# Access Compliance Report

## Public Rights-of-Way

| Intersection ID: 42701                  | Main Street: SHARON_VIEW_RD | Cross Street: COLEY VIEW CT             | Location: S            |
| ADA ID: 01EEC86E043B                    | Ramp Type: PerpDiag         | Initial Pass/Fail: Fail                 | Overall Compliance: No |

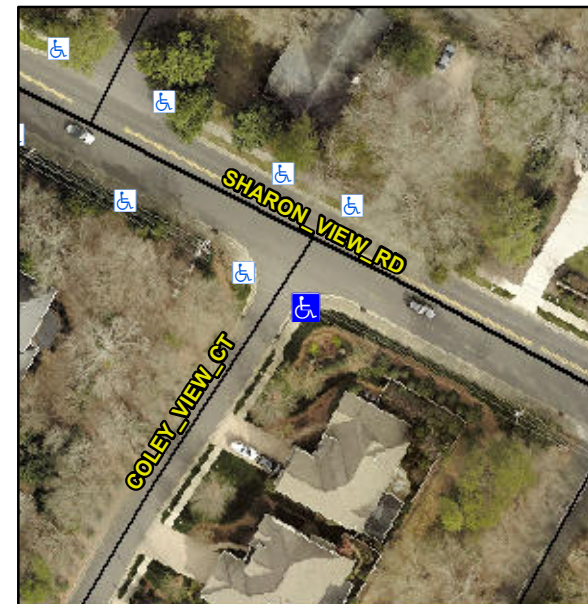
| Severity Score: 13.75                   |                             |   |                        |

**Not Found, R304.2.2, R304.5.3**

| Compliance | Description           | Data  | Compliance | Description                 | Data  |
|------------|-----------------------|-------|------------|-----------------------------|-------|
| N/A        | Ramp Length (in)      | 28.0  | No         | Ramp Slope (%)              | 8.7   |
| Yes        | Ramp Width (in)       | 48.0  | No         | Ramp XSlope (%)             | 2.9   |

**Remove & Replace Curb Ramp With Two New Directional Ramps or Equivalent.**
